**City of Richmond**  
Urban Development Division

## Report to Development Permit Panel

**To:** Development Permit Panel  
**From:** Joe Erceg  
Manager, Development Applications  
**Date:** December 13, 2002  
**File:** DP 02-203975  
**Re:** **Application by Memorial Gardens (BC) Ltd. for a Development Permit at  
8420 Cambie Road**

**Site Plan**  
 SCALE: 1" = 20'-0"  
 NORTH

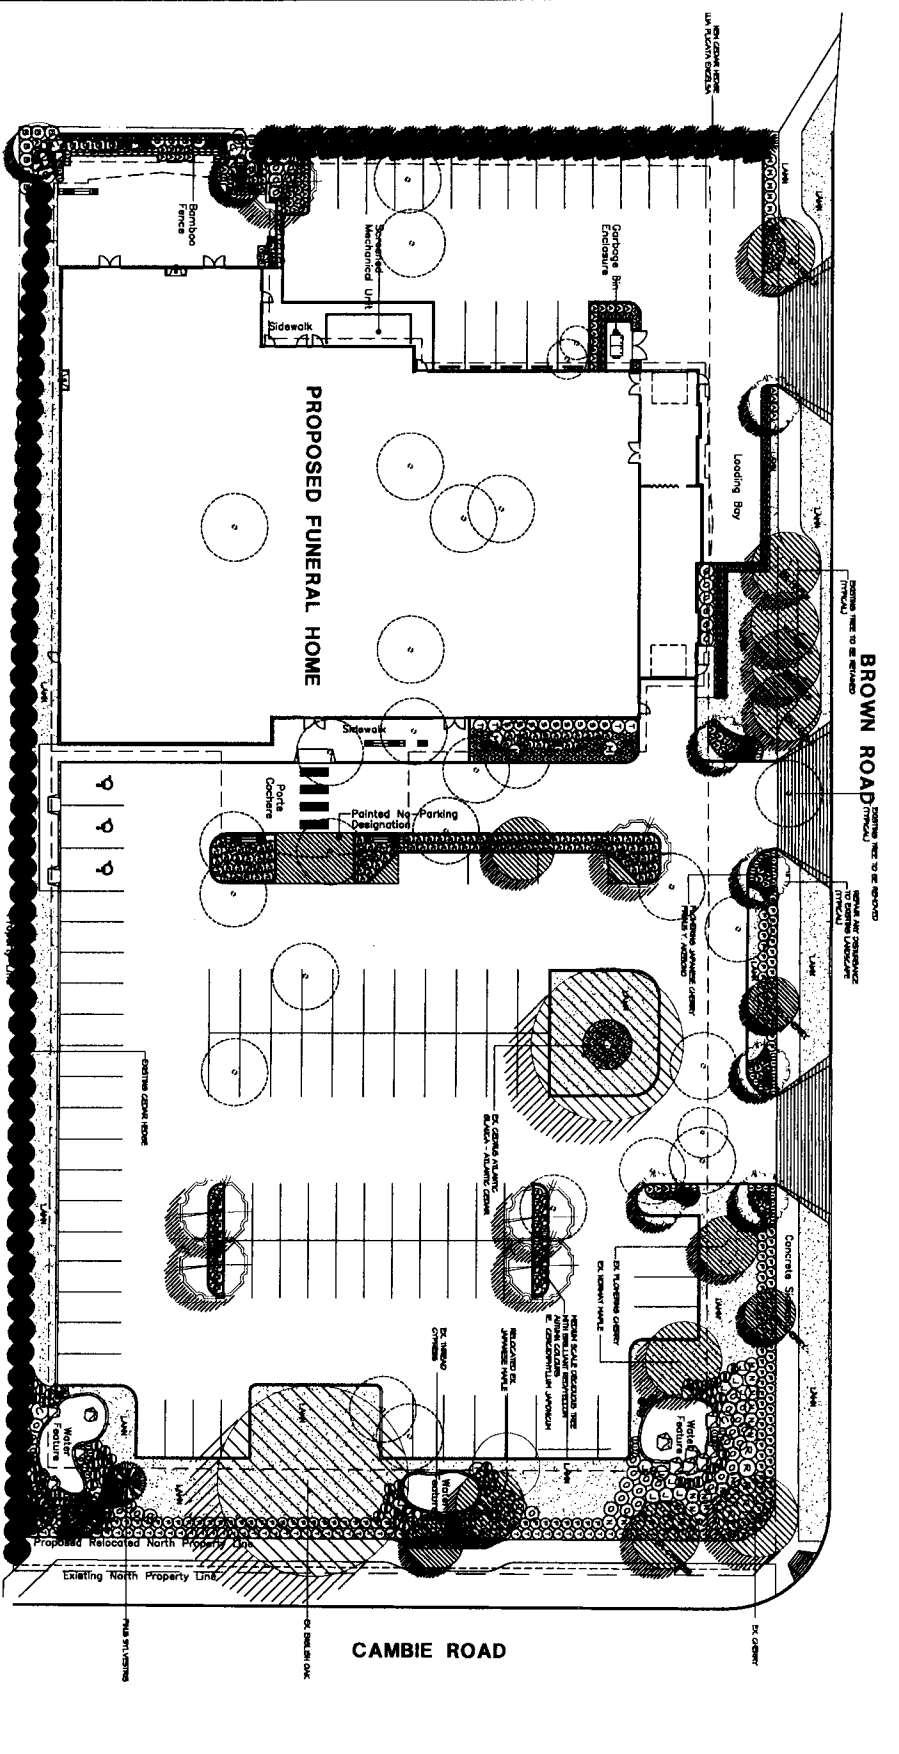
1. Consolidate the two northernmost driveways on Brown Road into one -- must not exceed maximum throat width (i.e. 7.5 m for two-way). ***Note: Staff have agreed to allow three (3) access points, in exchange for dedication of the road widening land on Cambie Road.***

2. Staff parking area – move landscape block to easternmost stall (currently at about fourth stall) to provide turnaround capability for the easternmost stall. Otherwise, provide hammerhead or move landscaping to provide turnaround capability. *The consultants have completely revised the parking lot.*
3. Address how parking will be accommodated and provided during construction. *The owner has arranged with churches in the neighbourhood to use their parking lots.*
4. Southernmost driveway must not exceed maximum throat width requirements (i.e. 7.5 m for two-way). *The consultants have completely revised the parking lot.*

The building looks good. Provide more trees in the parking lot. The width of the south driveway crossing should be greatly reduced so that the area in front of the building may be landscaped. Frontage work should be completed along Brown Road to City Centre standard. (This is consistent with the requirement that 4460 Brown Road does its frontage as a condition of Building Permit, and with what will be the standard for frontage work throughout the area). Similarly, it would be preferable to install a boulevard along Cambie Road and move the sidewalk back. This would require that a r.o.w. be secured and the existing hedge be removed. The hedge is nice but the streetscape would look better and be more safe and comfortable for pedestrians if the hedge was removed and a new hedge was planted near the head of the parking stalls. The sidewalk does not need to go in a straight line; it can meander to accommodate the existing trees and other landscape features.

The applicant has agreed to a road widening dedication on Cambie Road, frontage improvements, and tree preservation. Because of City road requirements and tree preservation, the consultants re-designed the parking lot and lost 12 spaces. In addition, they increased the number of small-car spaces. All staff feel that this is a fair trade-off, and the resulting variances should be supported.

**LANDSCAPE PLAN**

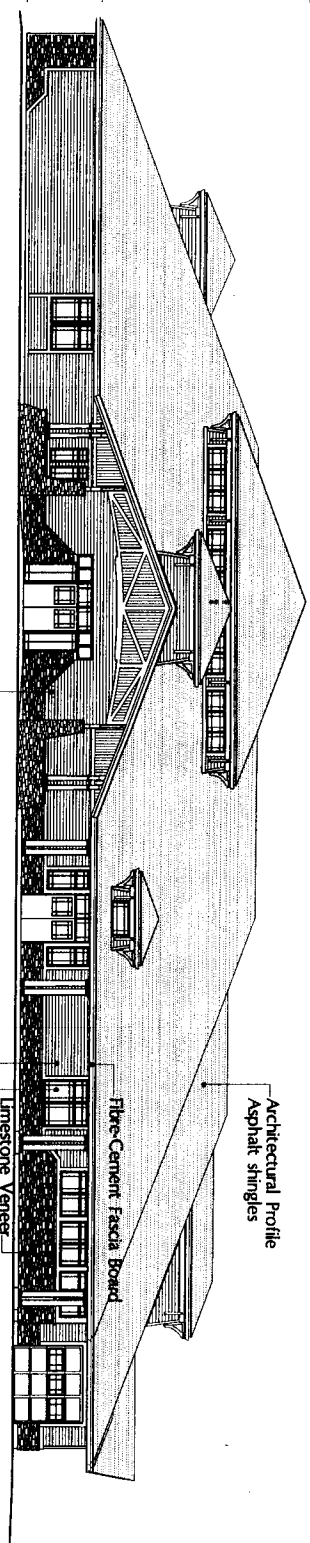
We have a copy of a tree survey, but the landscape architect should take the information and plot it at the same scale as the landscape plan. It should be possible, then, to preserve a number of trees in the parking lot. In any case, all of the trees should be shown on the plan. Trees larger than 8 in. caliper that are removed should each be replaced with a minimum of two 4" caliper trees (show on the plant list). An arbourist should be retained to evaluate the trees, prepare a tree management plan, and supervise the work around the trees during construction. Tree-protection fences should be erected on the site (show on landscape plan).

- the reduced landscape plan was difficult to read;
- the driveway from Brown Road could be smaller; more normal;
- the parking lot would benefit from more trees;
- new hedging should be closely spaced;
- stone works at the corners might be better conglomerated around certain areas, i.e. the entry and central main gables, rather than spread out;
- door 27 in the south-east corner too vulnerable to break in, as are door 10 and window 5;
- real stone would be a larger success;
- the garage door on the front of the building should be chosen to better blend with the design of the building;
- parking area could be broken up with more green in the middle;
- considerations of accessibility should be given to viewing positions in the Chapel;
- unisex washrooms would be desirable;

***The consultants have complied with the request, and have integrated a number of mature trees into the parking lot design. In particular, an Oak and a Himalayan Cedar, both with trunks over a metre in diameter, have been retained. As a result, the applicant is proposing a slight parking variance to reduce the number of spaces and to add additional small cars.***
